**SUBJECT:** **NEW VEHICLE DEMONSTRATION / DELIVERY HOLD - Safety Recall 19S17 – Supplement #3**  
 Certain 2011-2017 Model Year Explorer Vehicles  
 Rear Suspension Toe Link Replacement

*An updated rear toe link design has been released.*

**FIGURE 2**

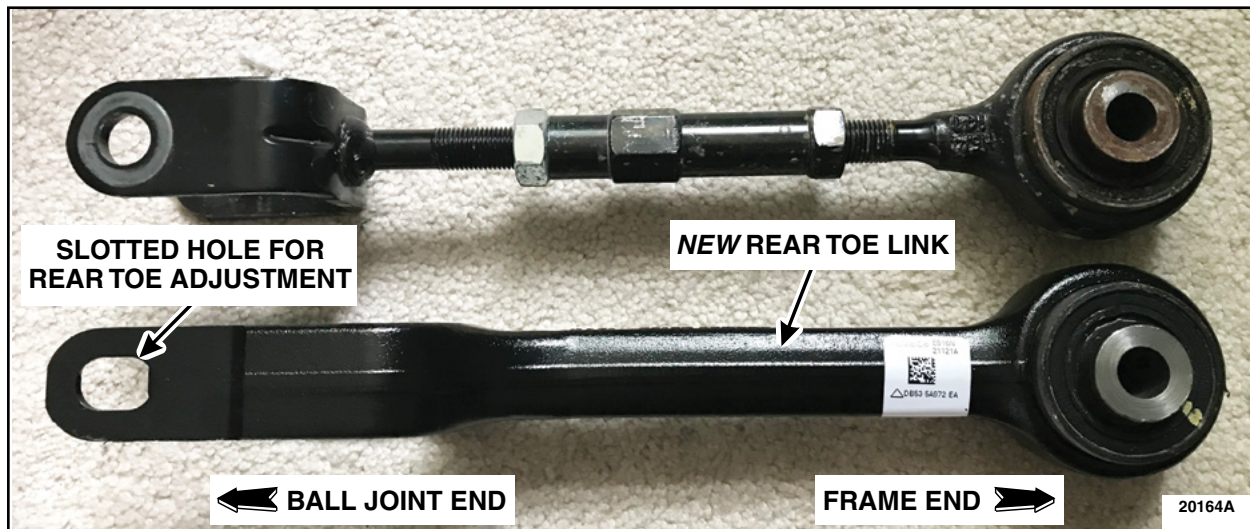
**NOTE:** the frame side of the new toe link has a slot that is used for the alignment process. See Figure 2.
